COMMENTS ON D'APPOLONIA'S FLOW MODEL AND HYDROLOGIC IMPACT ANALYSIS  
OF THE CRANDON SITE AS DOCUMENTED IN APPENDIX 4.1A OF THE EIR

COMMENTS PREPARED BY  
DR. MARY P. ANDERSON

AUGUST 1983  
REVISED JANUARY 1984

FIGURE 1. LAKE RECHARGE RATES

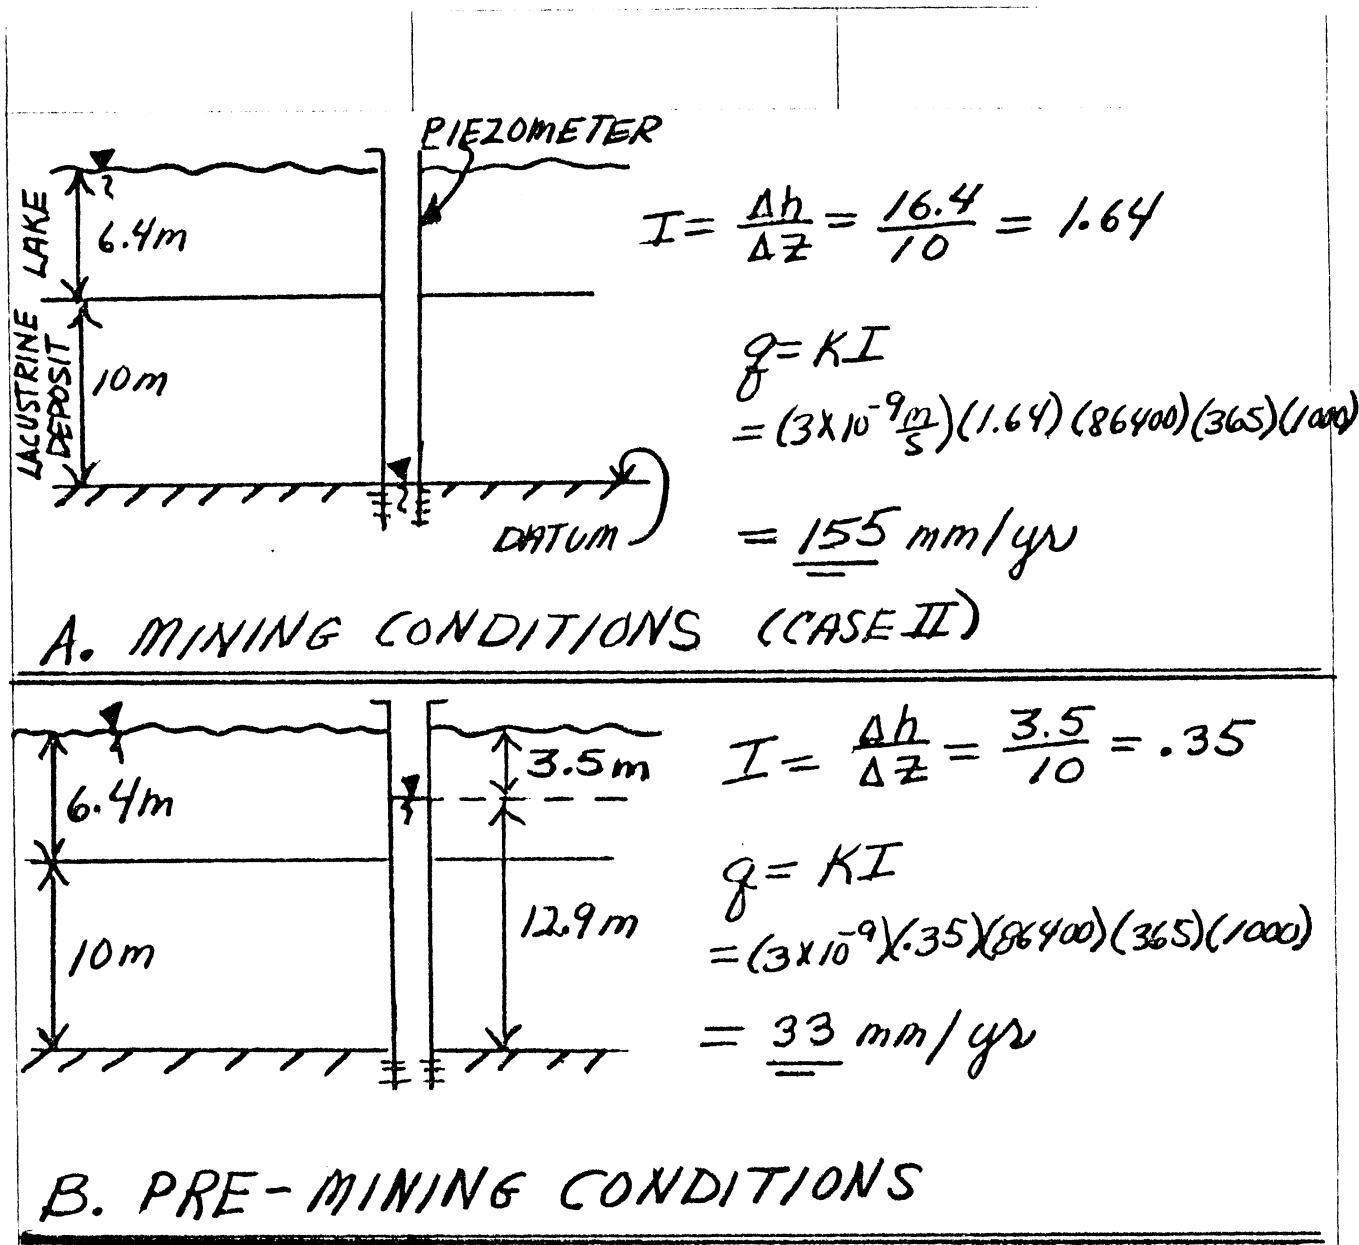
2. I was not able to reproduce the numbers for maximum and minimum recharge rates given in Table A-12. Little Sand Lake is used as an example. I assumed a maximum lake depth of 6.4 m (from Table A-10) and an average depth of 10 m for the lacustrine deposit beneath the lake (from Table A-12). The vertical hydraulic conductivity of the lacustrine deposit was assumed to be  $3E-9$  m/s (from Table A-6). My calculations are shown in Figure 1.

According to my calculations the recharge rate beneath Little Sand Lake would be 155 mm/yr if the potentiometric surface drops to the base of the lacustrine layer (my Fig. 1A). Under pre-mining conditions the recharge rate is only 33 mm/yr (my Fig. 1B). EXXON used a value of 117 mm/yr for seepage from Little Sand Lake both before and during mine dewatering. My calculations indicate instead that seepage rate will increase by 122 mm/yr during mining. This increase translates to a drop in lake level of 0.122 m/yr, assuming no net inflow of water to the lake (i.e., assuming that precipitation equals evaporation and that there is no surface runoff to the lake). If the potentiometric surface drops to the base of the lacustrine layer after 3 years, the lake level will drop 0.122 m/yr for 30 years or a total of 3.66 meters, again assuming no net inflow of water to the lake. Given that precipitation exceeds evaporation in Wisconsin, it would be expected that contributions of water from precipitation and possibly from surface runoff would mitigate any decline in lake level. EXXON SHOULD PROVIDE WATER BUDGET ANALYSES FOR ALL THE INTERNAL LAKES TO DEMONSTRATE THE EFFECT OF DEWATERING ON LAKE LEVEL. Without results of lake water budget analyses, there is no justification for the statement that: "The results showed a small increase in recharge from the lakes and a negligible variation in lake levels." (p. A-65 of Appendix 4.1A).

AS PART OF A SENSITIVITY CHECK, THE STEADY STATE CALIBRATION AS WELL AS THE TRANSIENT IMPACT ANALYSIS SHOULD BE DONE USING A HIGHER VALUE (e.g.,  $3E-8$  m/sec) FOR THE HYDRAULIC CONDUCTIVITY OF THE LACUSTRINE DEPOSITS.
